Site Accessibility Evaluation

Americans with Disabilities Act Title II (Public Services: State and Local Government)

Centennial Hall

Accessibility Evaluation

Finding: 1

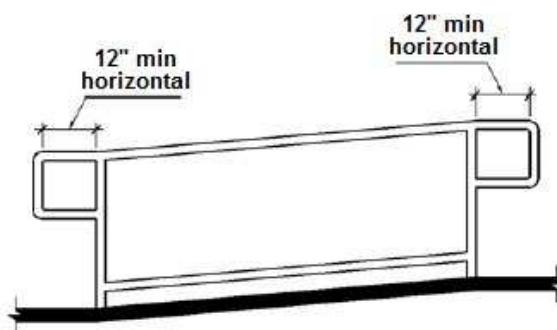
The handrail does not extend horizontally.

Handrail does not extend full length of ramp

Modify existing handrails to extend the full length of the ramp.

Finding: 2

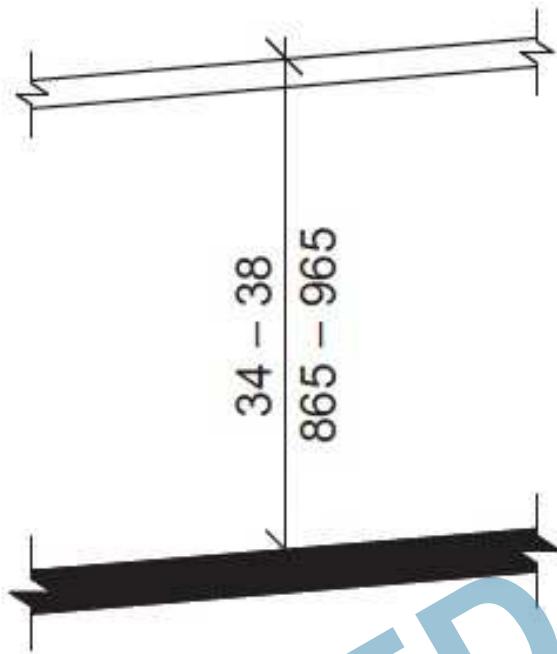
The handrails are mounted too low.

Handrail height
between 32 and 33
inches above finished
floor

Modify existing handrails and ensure handrails are installed between 34 inches and 38 inches above finished floor.

Finding: 3

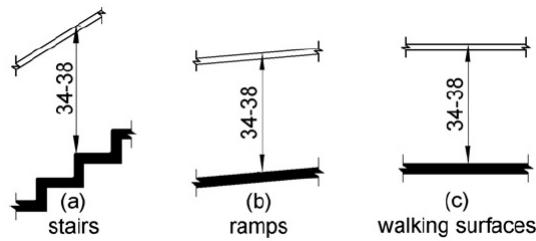
The handrails as well as the handrail extensions are not at the correct height.

**Handrails below 34
inches minimum
height required**

Re-place existing handrails with handrails no lower than 34 inches from the top of the griping surface and ensure extensions are also included at the top and bottom landings.

Finding: 4

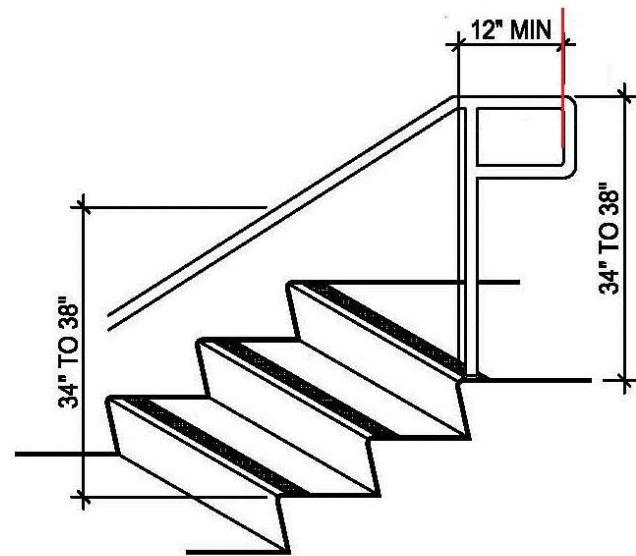
The handrail projects less than 12 inches beyond the landing at the top of the stairs parallel to the floor or ground.

31.75 inches above
finished floor

Re-construct or modify existing handrails and ensure handrails are installed between 34 inches and 38 inches above finished floor and extend horizontally above the landing for 12 inches minimum.

Finding: 6

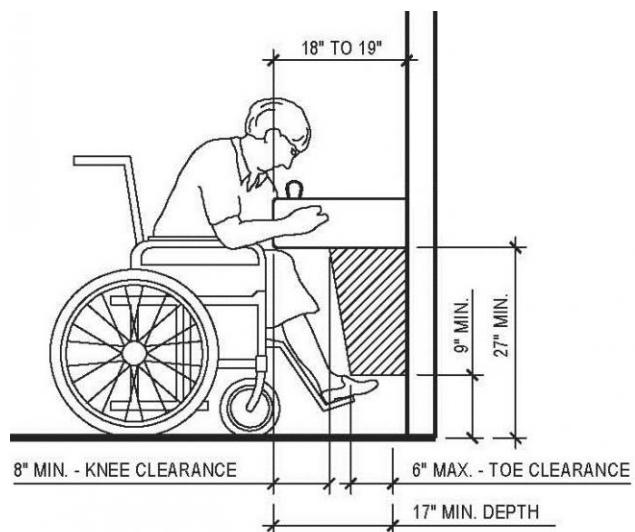
There is not enough knee clearance under the drinking fountain.

Bottom edge of
drinking fountain at
26.5 inches

Adjust drinking fountain height to provide 27 inches of clearance.

Finding: 7

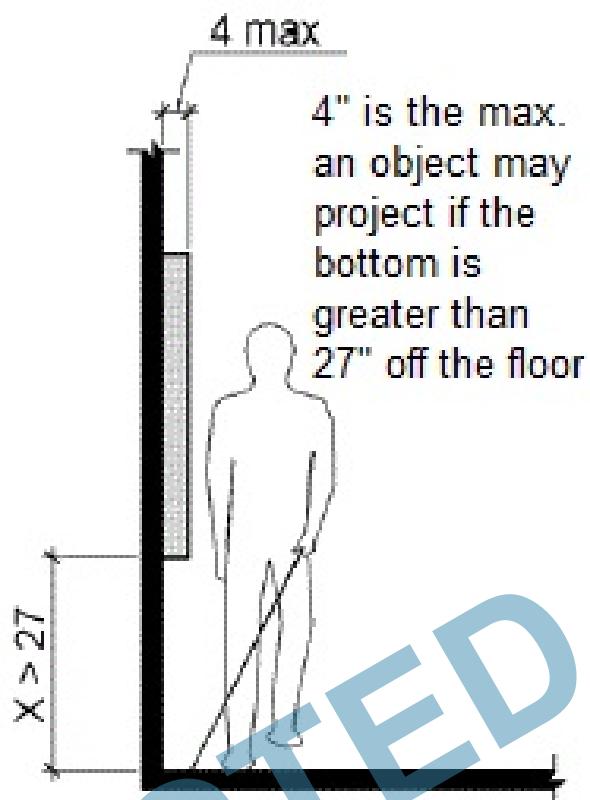
The fire alarm housing projects more than 4 inches into the circulation path.

Protrudes 6 inches
from wall

If possible, replace fire alarm housing with low profile housing or recess housing into wall to meet the 4 inch maximum protrusion.

Finding: 8

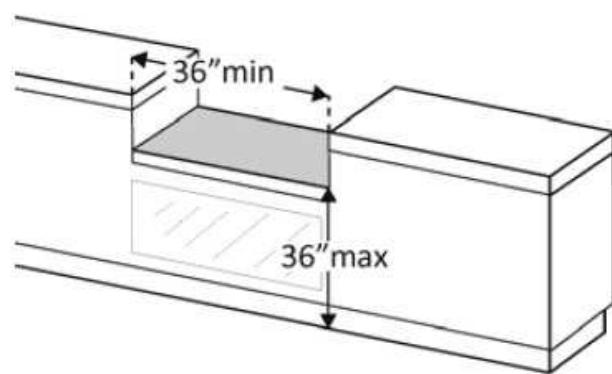
The transaction counter is too high.

**42 inches above
finished floor**

Install compliant service counter or addition to existing service counter that includes a section of counter surface that is 36 inches long minimum and 36 inches high maximum.

Finding: 9

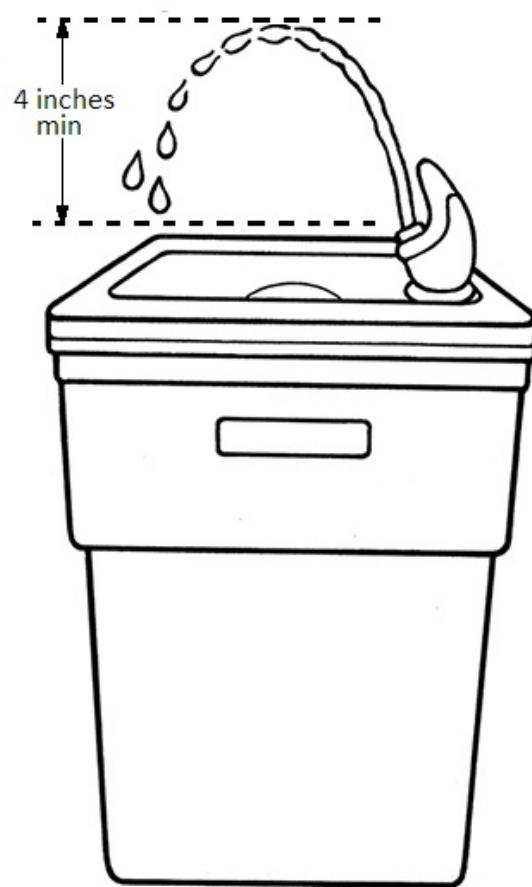
The water flow from the spout is too low..

**1.5 inches flow of
water**

Adjust water flow pressure to provide flow of water 4 inches high minimum.

Finding: 10

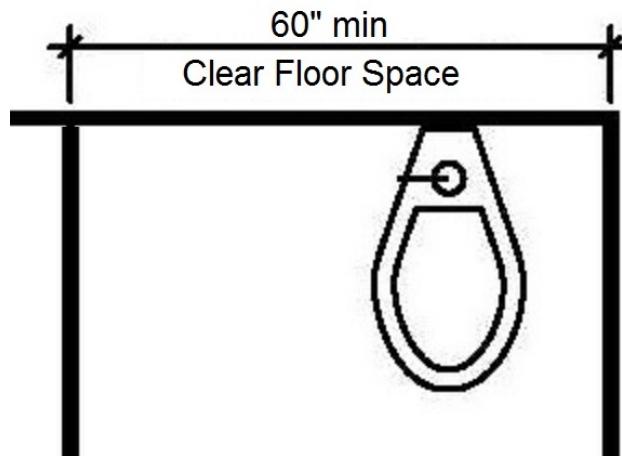
The toilet compartment is not wide enough.

40 inches wide

Re-design and remodel restroom to meet compliance to the extent feasible.

Finding: 11

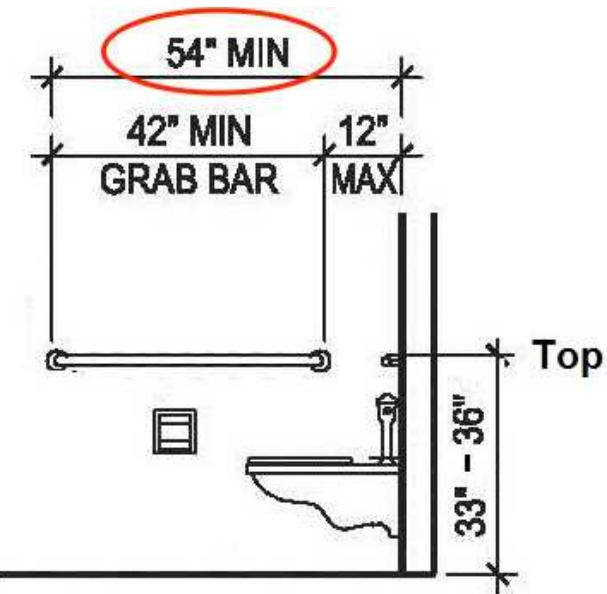
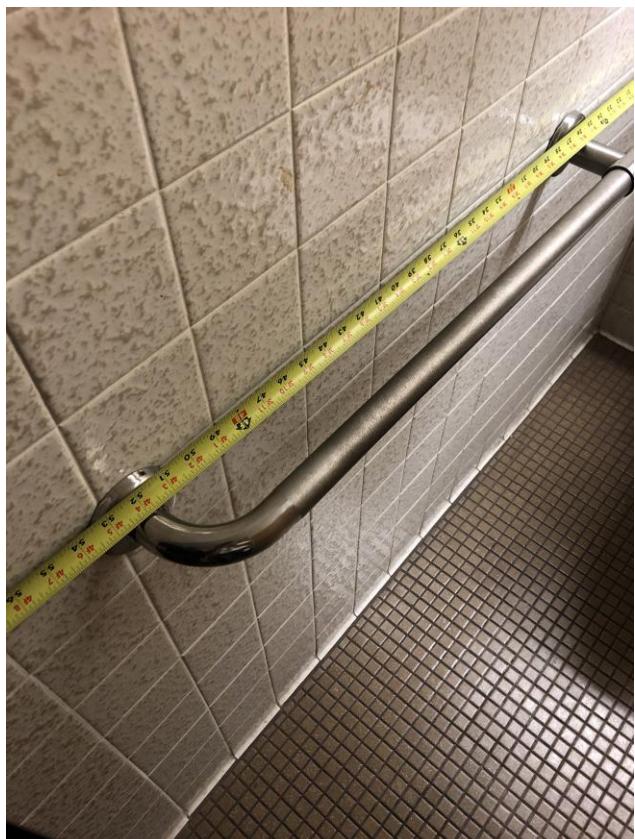
The side grab bar does not extend far enough from the rear wall.

10 inches from rear
wall

Upon remodel install new side grab bar to meet compliance.

Finding: 12

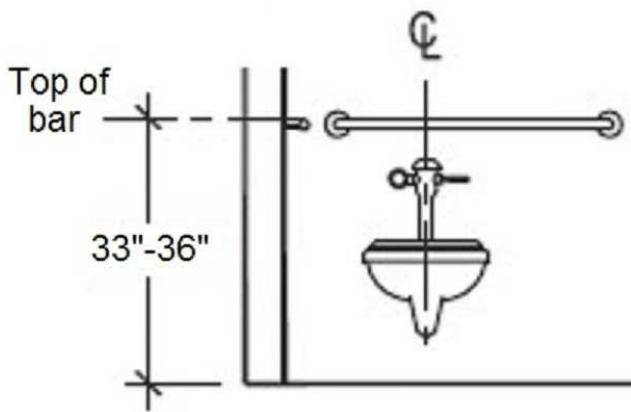
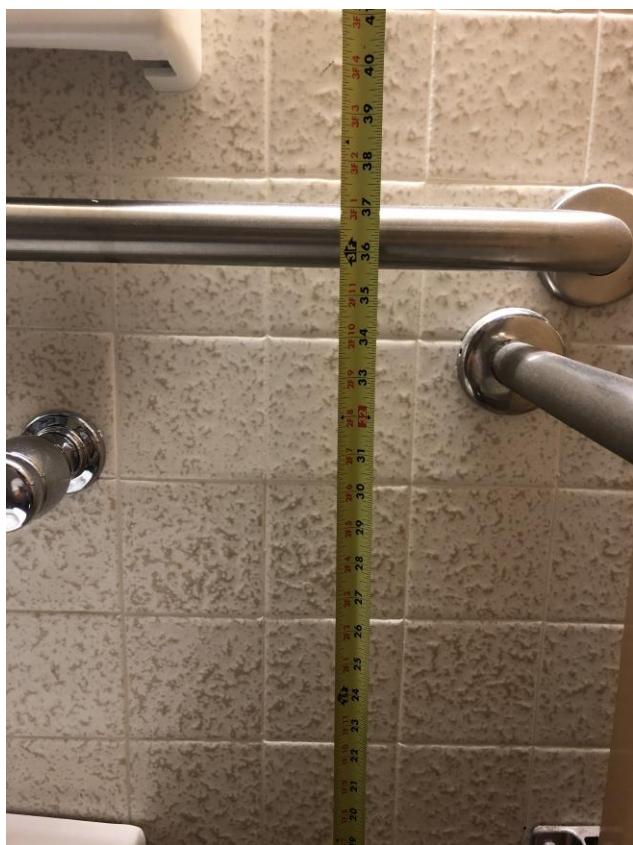
The rear grab bar is too high.

37 inches above
finished floor

Lower grab bar between 1 and 3 inches to meet compliance.

Finding: 13

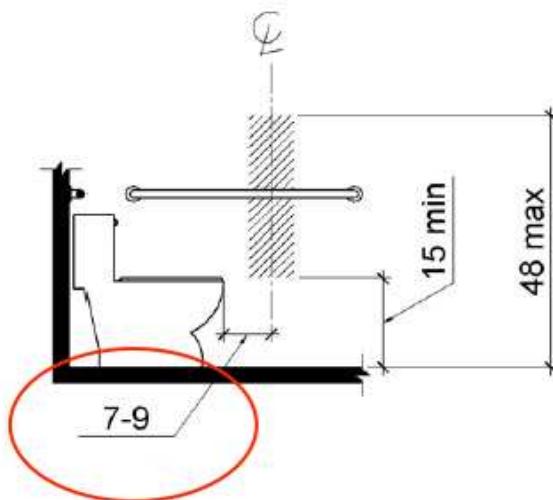
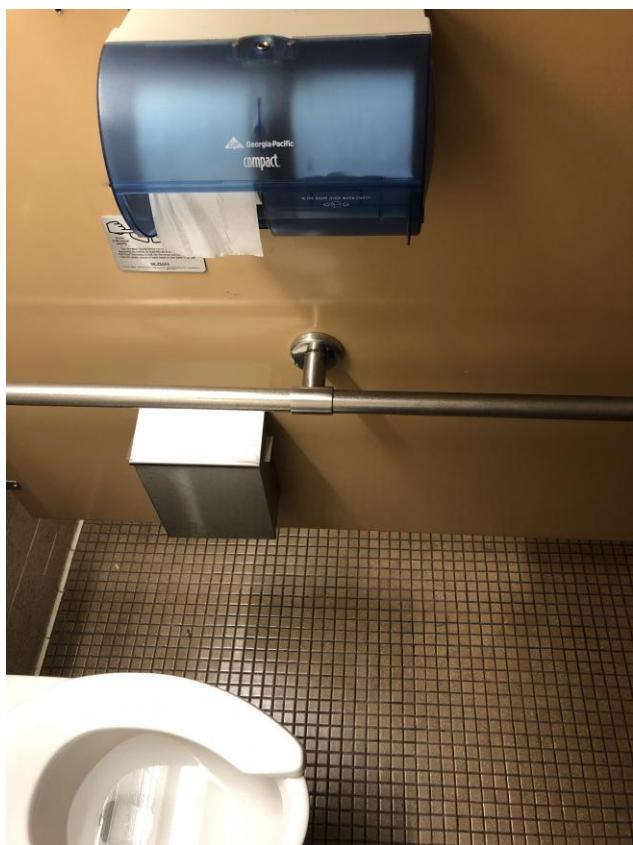
The toilet paper is not installed within the compliant range in front of the toilet.

2 inches in front of
toilet

Re-design and remodel restroom to meet compliance to the extent feasible.

Finding: 14

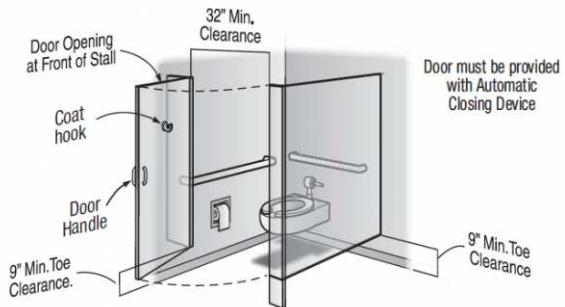
The compartment door is not self closing.

Door not-self closing

Re-design and remodel restroom to meet compliance to the extent feasible.

Finding: 15

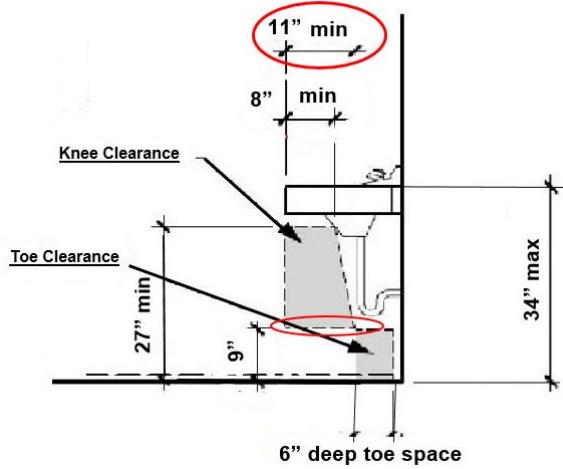
Compliant knee space has not been provided under the lavatory.

No knee clearance
provided

Replace lavatory with compliant unit that meets ADA standards.

Finding: 16

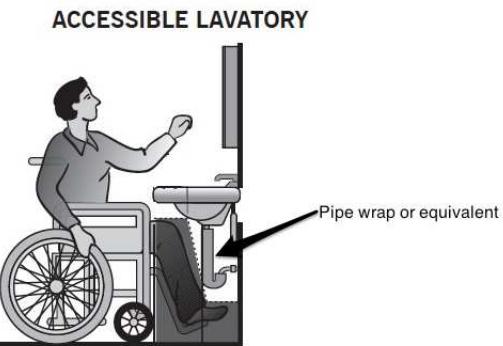
The water and drain pipes under the lavatory are not adequately insulated.

No insulation installed

Install pipe insulation prior or during re-model.

Finding: 17

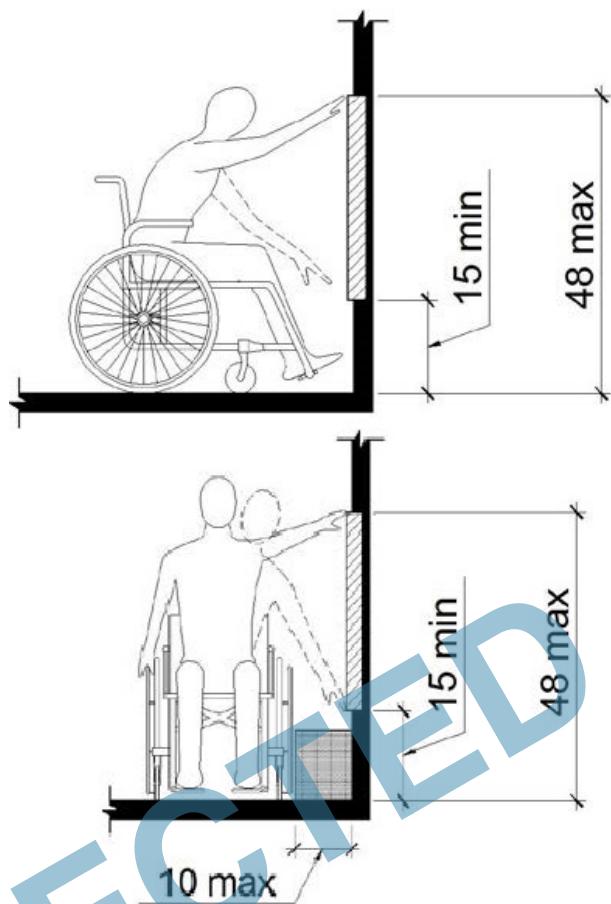
The baby changing table operating mechanism is outside reach range.

Operable part is at 60
inches above finished
floor

Replace with horizontal baby changing table and install with operable handle no higher than 48 inches above finished floor.

Finding: 18

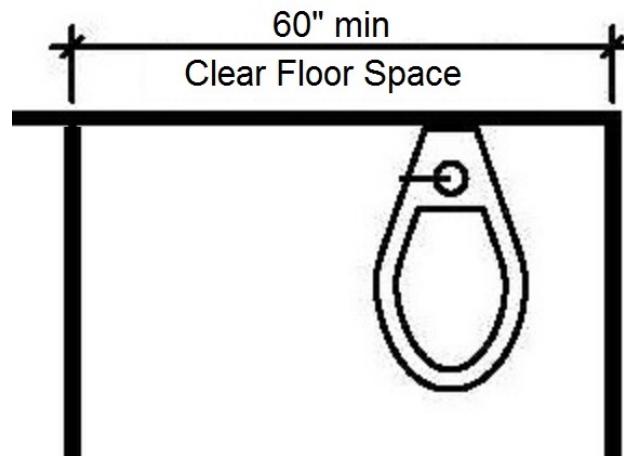
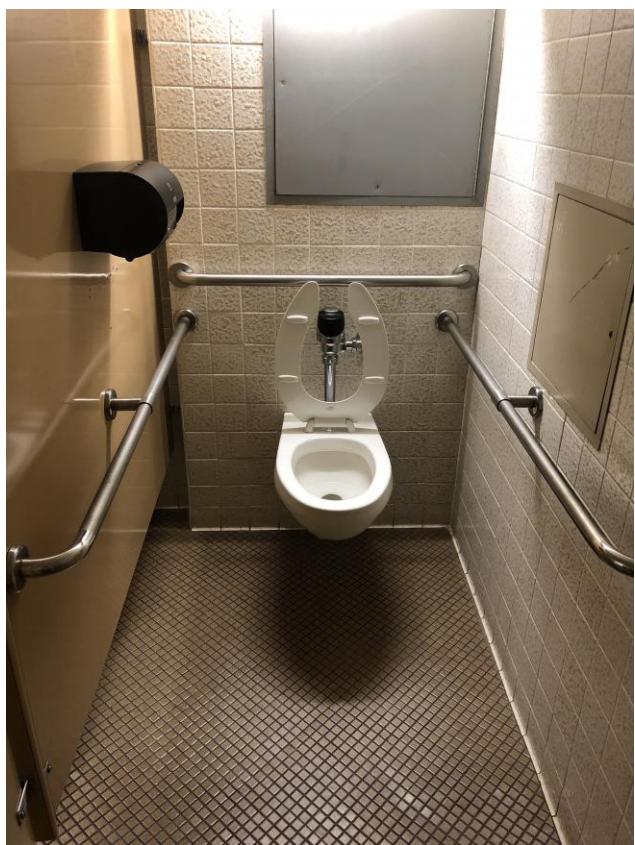
The toilet compartment is not wide enough.

41 inches wide

Re-design and remodel restroom to meet compliance to the extent feasible.

Finding: 20

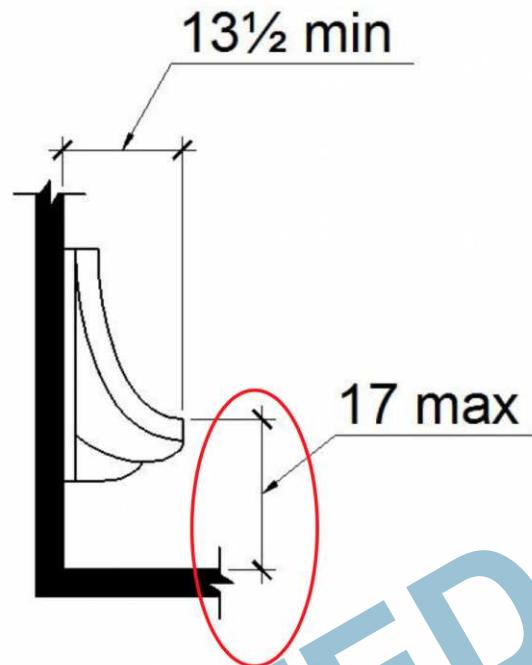
The rim of the urinal is too high.

18.5 inches above
finished floor

Lower urinal 2 inches or replace with compliant urinal.

Finding: 21

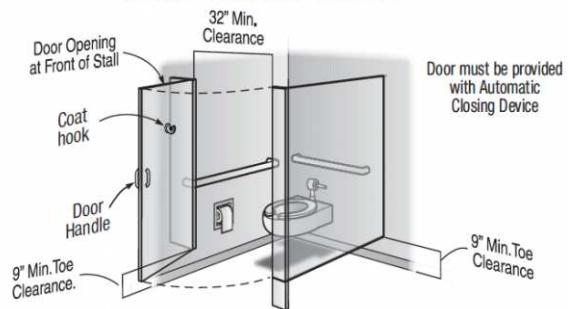
The compartment door is not self closing.

Door not-self closing

Re-design and remodel restroom to meet compliance to the extent feasible.

Finding: 22

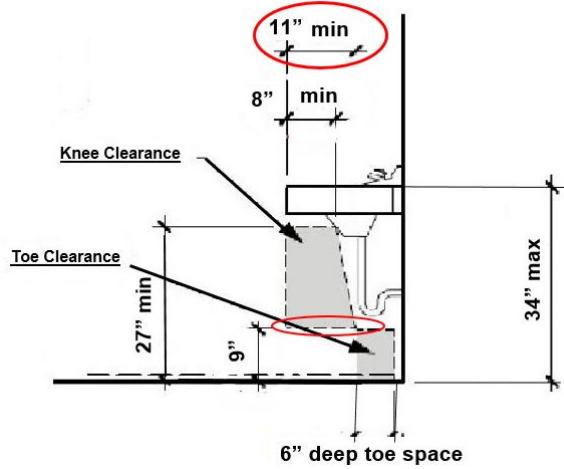
Compliant knee space has not been provided under the lavatory.

No knee clearance
provided

Replace lavatory with compliant unit that meets ADA standards.

Finding: 23

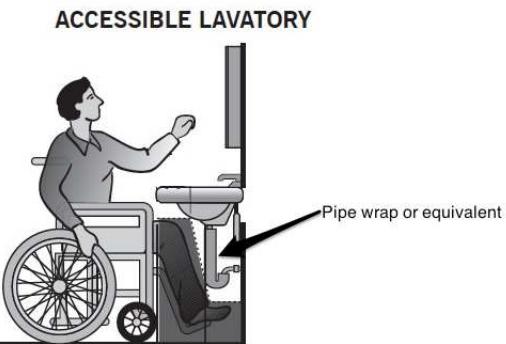
The water and drain pipes under the lavatory are not adequately insulated.

No insulation installed

Install pipe insulation prior or during re-model.

Finding: 24

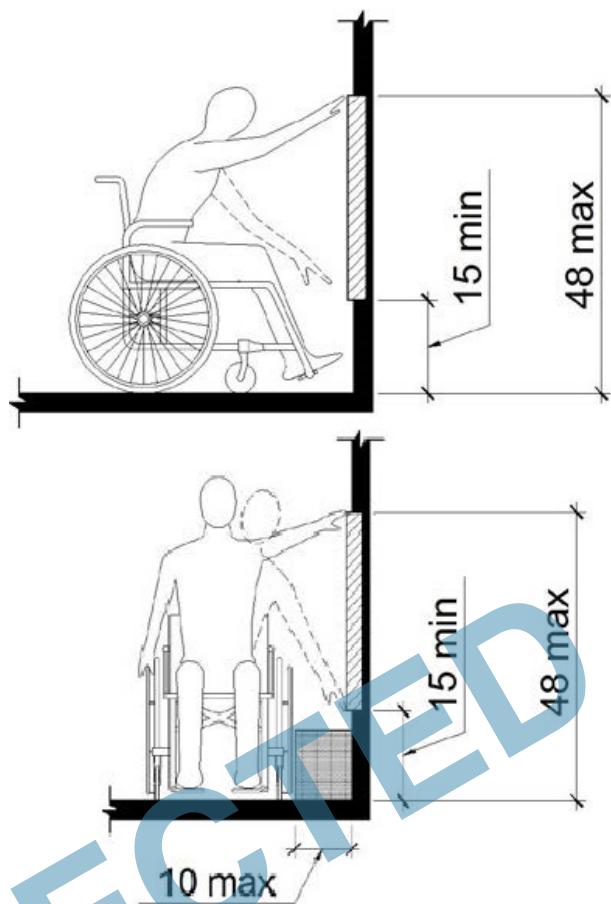
The baby changing table operating mechanism is outside reach range.

Operable part is at 60
inches above finished
floor

Replace with horizontal baby changing table and install with operable no higher than 48 inches above finished floor.

Finding: 25

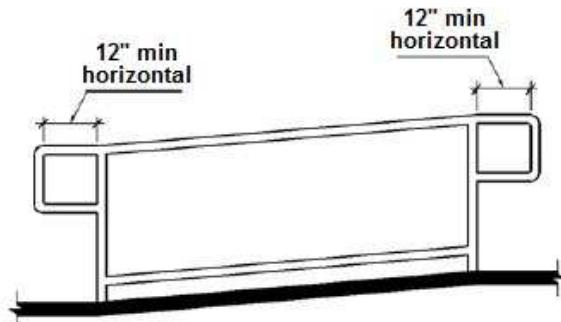
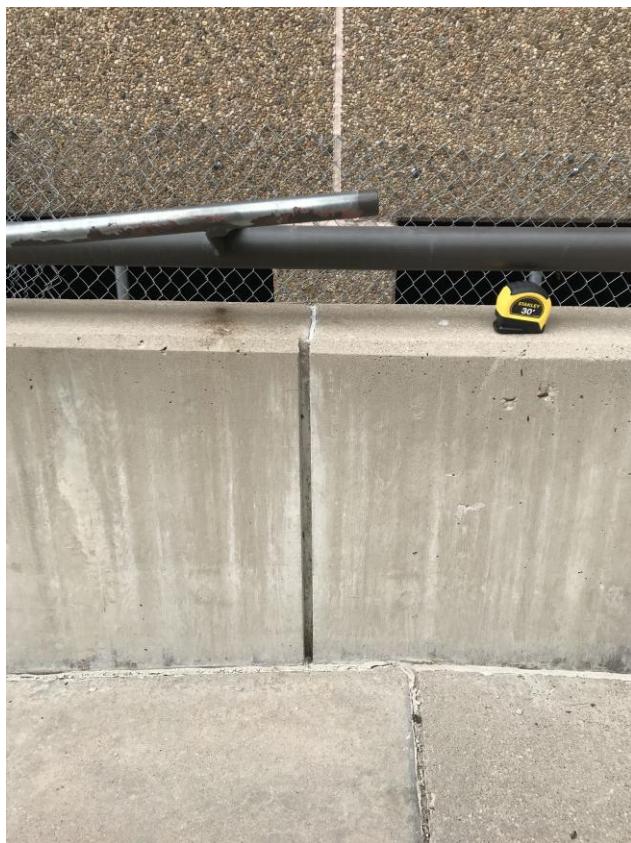
The handrail does not extend horizontally.

Handrail does not extend horizontally

Extend extension 12 inches minimum horizontally beyond the top and return rail to wall, handrail or ground.

Finding: 26

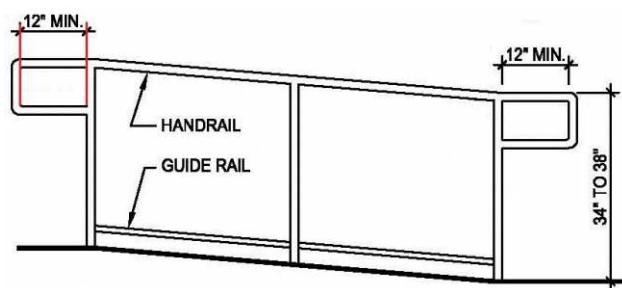
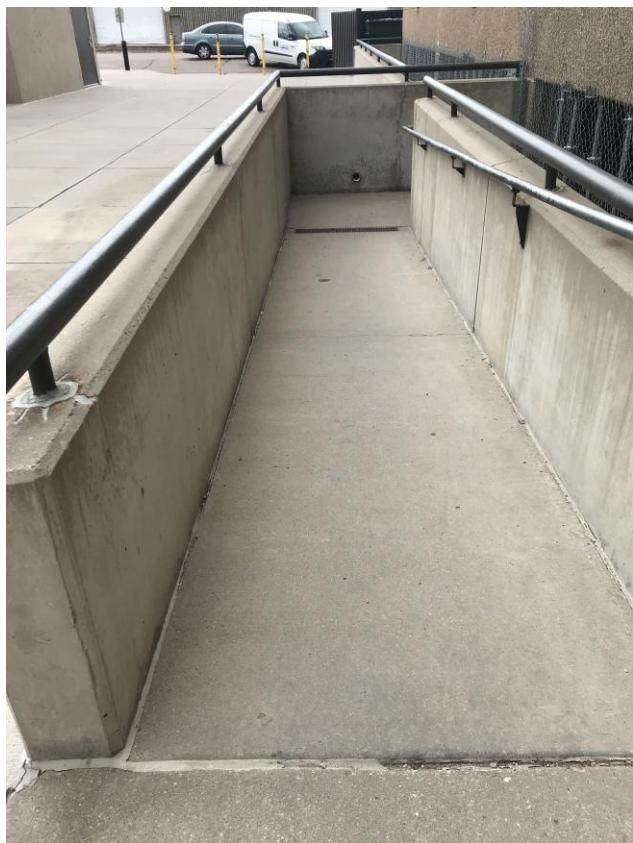
The ramp does not have compliant handrails.
